# Access Compliance Report

## Public Rights-of-Way

### (Curb Ramps)

| Intersection ID: 3047 | Main Street: BUCK_CT | Cross Street: WHITE_STAG_DR | Location: NE           |

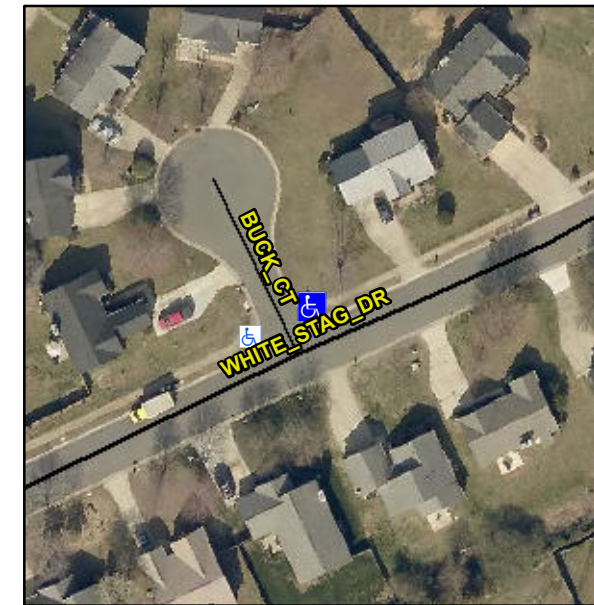
| ADA ID: A6D9E9FCB90F  | Ramp Type: Perp      | Initial Pass/Fail: Fail     | Overall Compliance: No |

**Not Found, R304.5.1**

| Compliance | Description           | Data | Compliance | Description                 | Data |
|------------|-----------------------|------|------------|-----------------------------|------|
| No         | Ramp Width (in)       | 41.0 | Yes        | Ramp XSlope (%)             | 1.6  |

**Remove & Replace Entire Ramp.**
